Tobias Horte

Office Action Summary	Application No. 10/581,351	Applicant(s) HORTE, TOBIAS	
	Examiner Tho v. Duong	Art Unit 3744

DETAILED ACTION

Figure A: the modified figure corresponds to figure 3 with limitation of second plate shown.

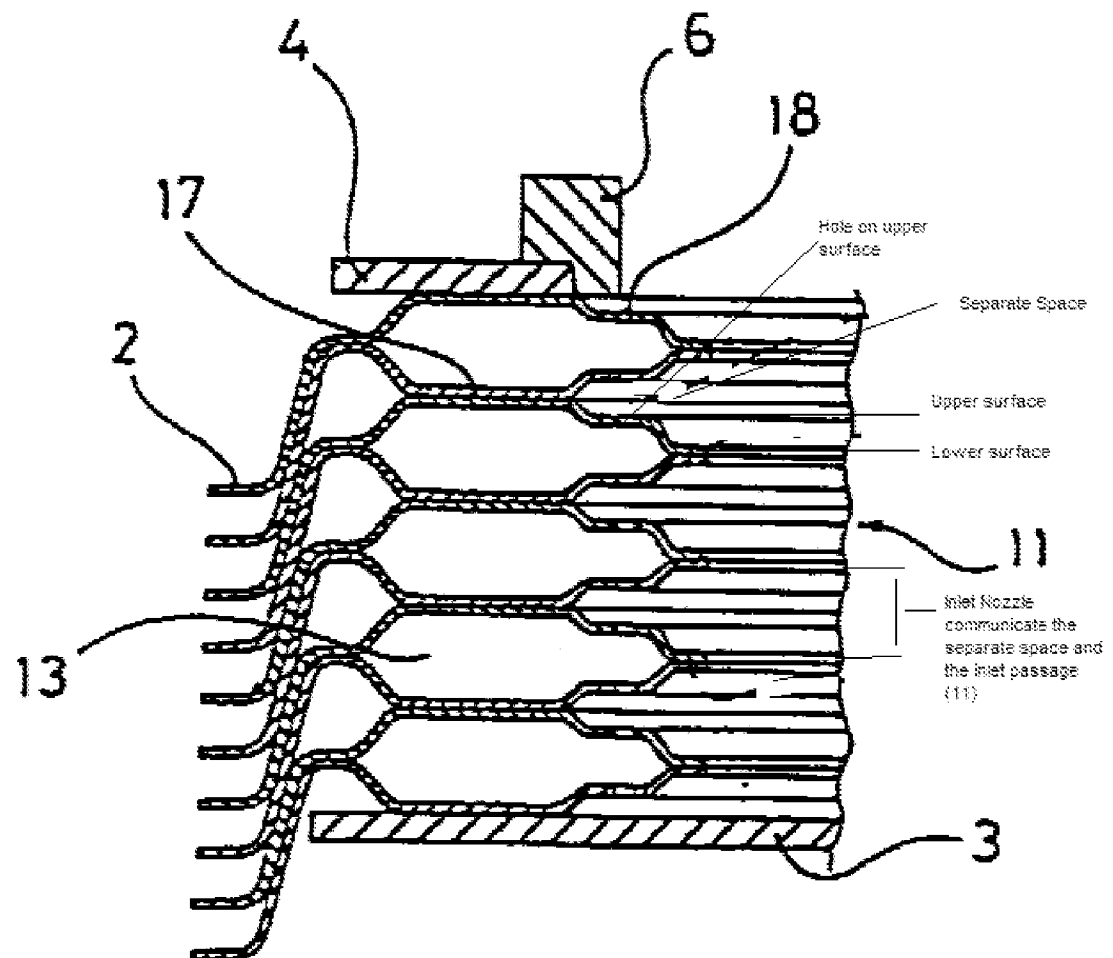
Claims 25-26,32,33,39,40,41,44,45,46,47 and 48 are rejected under 35 U.S.C. 102(b) as being anticipated by Anderson et al. (US 5,924,484). Anderson discloses (figures 1 and 3) a plate heat exchanger comprising a plate package, the plate package including a number of first heat exchanger plates and a number of second heat exchanger plates; the plates (2) being permanent joined to each other and arranged beside each other so that a first plate interspace (13) is formed between each pair of adjacent first and second heat exchanger plate, and so that a second plate interspace (shown as outside of 13) is formed between each pair of adjacent second heat exchanger plates and first exchanger plates, wherein the first plate interspaces (13) and the second interspaces are separated from each other and provided beside each other in alternating order in the plate package; wherein substantially each heat exchanger plate has at least a first porthole and a second port (9), the first port holes forming a first inlet channel (11) to the first plate interspaces and the second portholes forming a first outlet channel from the first plate interspaces; wherein the plate package includes a separate space (15) for each of the first plate interspaces, which space is closed to the second plate interspaces; wherein the separate space (15) communicates with the first inlet channel via an inlet nozzle (shown in figure A as gap between portion 16), which forms a throttling with significantly reduced flow area (compare with port (9)), and with the respective first plate interspace via an outlet nozzle (18), which forms a throttling with significantly reduced flow area; the separate space (15) is provided in the proximity of the inlet channel. Regarding claims 28 and 30,32-34, each of the second heat

exchanger plates (2); each of the heat exchanger plates (2) includes a central extension plane, an upper plate plane on one side of the central extension and a lower plate plane on the other side of the central extension plane; each of the second heat exchanger plates includes an upper surface area, which extends around the first porthole and which delimits the separate space, and the upper surface area is located at the level of the upper plate plane; the upper surface area of the second heat exchanger plates is located partly opposite to the lower surface area of the first plates for forming the separate space between these surface areas, the outlet nozzle is formed by a respective hole, which extends through the upper surface area; the heat exchanger includes an end plate, which is provided adjacent to one of the second heat exchanger plates and closes the hole of the outlet nozzle of the second heat exchanger plate (figure 3). Regarding claim 36, Anderson discloses (figure A) each of the second heat exchanger plate includes a lower surface area, which extends around the first port hole (9) between the first port hole and the upper surface area, wherein the lower surface area is located at the level of the lower plate plane; Anderson further disclose (figure A) that each of the first heat exchanger plate includes a lower surface area, which extends around the first porthole (9) and which delimit the separate space, wherein the upper surface area of the second heat exchanger plate is located partly opposite to the lower surface area of the first heat exchanger plates for forming the separated space (15) between these surface areas; the lower surface area of the second heat exchanger is located partly opposite to the upper surface of the first heat exchanger plate, wherein these two surface areas partly abut each other in the plate package. Regarding claims 29,31, 39,40 and 41, another interpretation of the separate space is shown in figure B.

the inlet nozzle is located opposite to the lower surface area of the first heat exchanger plates (inlet nozzle located above the lower surface area); the outlet nozzle (18), with regard to the central extension plane, is displaced in relation to the lower surface area of the first heat exchanger plates (the outlet nozzle (18) is not located on the lower surface area of the first heat exchanger plate); the first plate and second plate interspaces form first and second fluid passages for two different fluids; each of the heat exchanger plate further has a third and fourth port holes (figure 1).
